RICHARDSON LANE FROM LINE ROAD

ADDRESS:  
12260 SMITH ROAD  
DESCRIPTION:  
FALCON RANCHES  
LOT 7 BLOCK 1 SUB 1  
EL PASO COUNTY, CO

Please add:  
PCD  
File No.  
VA266

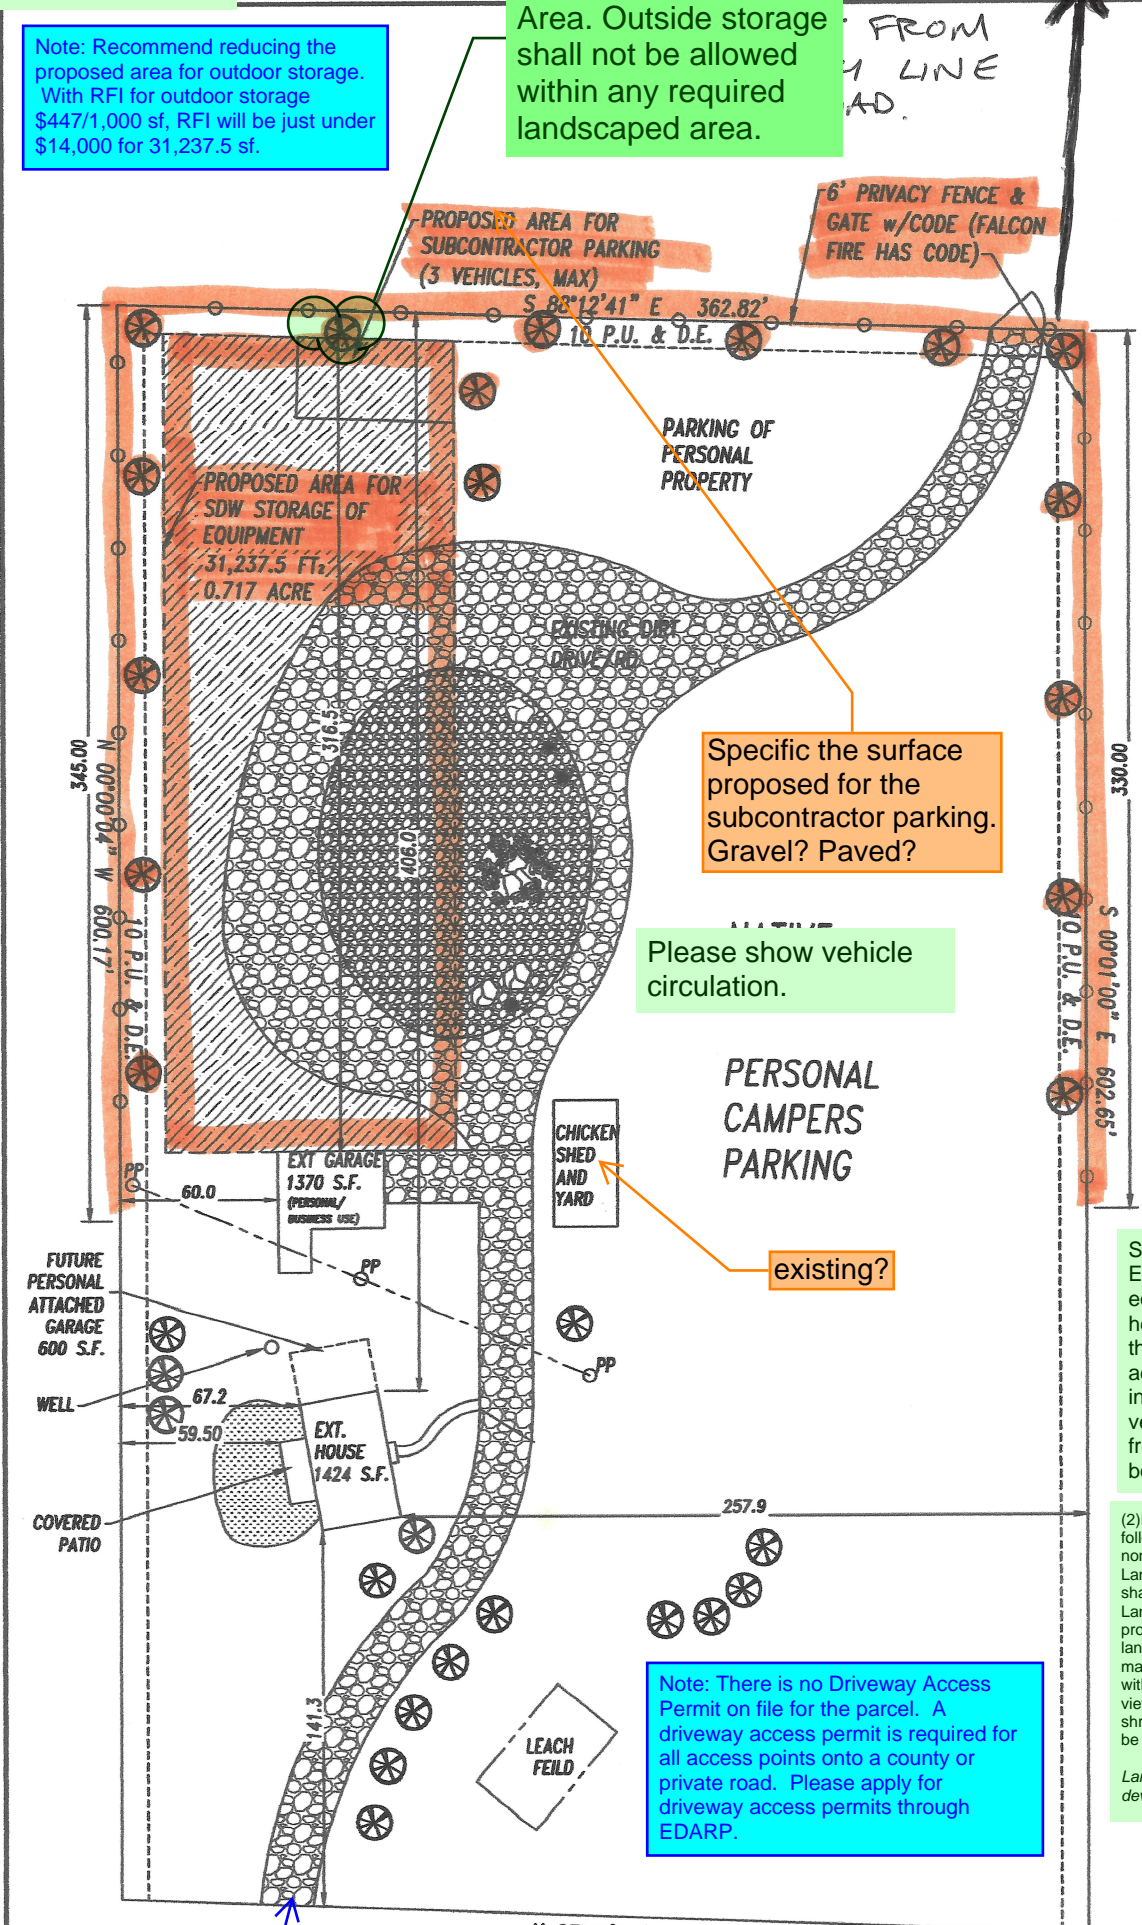
Please show proposed parking spaces.

No Storage in Required Landscape Area. Outside storage shall not be allowed within any required landscaped area.

Note: Recommend reducing the proposed area for outdoor storage. With RFI for outdoor storage \$447/1,000 sf, RFI will be just under \$14,000 for 31,237.5 sf.

Storage of Equipment and Vehicles Exceeding Height of Fence. All equipment and vehicles exceeding the height of the fence shall be stored on the rear 1/3 of the property except when adjacent to a residential zoning district, in which case the equipment or vehicles shall be a minimum 50 feet from the residential zoning district boundary.

Landscape plan to be submitted in future site development plan.

Specific the surface proposed for the subcontractor parking. Gravel? Paved?

Please show vehicle circulation.

existing?

Note: There is no Driveway Access Permit on file for the parcel. A driveway access permit is required for all access points onto a county or private road. Please apply for driveway access permits through EDARP.

Label width of driveway access at right-of-way for all accesses.  
ECM 2.4.1.E, Two-Way Commercial or Industrial Points. Two-way commercial or industrial parcel access points shall have:  
\*For nonresidential collector and local roadways: a minimum 25-foot and maximum 40-foot access width.

Add note stating: The owner agrees on behalf of him/herself and any developer or builder successors and assignees that Subdivider and/or said successors and assigns shall be required to pay traffic impact fees in accordance with the El Paso County Road Impact Fee Program Resolution (Resolution No. 25-337), or any amendments thereto, at or prior to the time of building permit submittals. The fee obligation, if not paid at final plat recording, shall be documented on all sales documents and on plat notes to ensure that a title search would find the fee obligation before sale of the property.
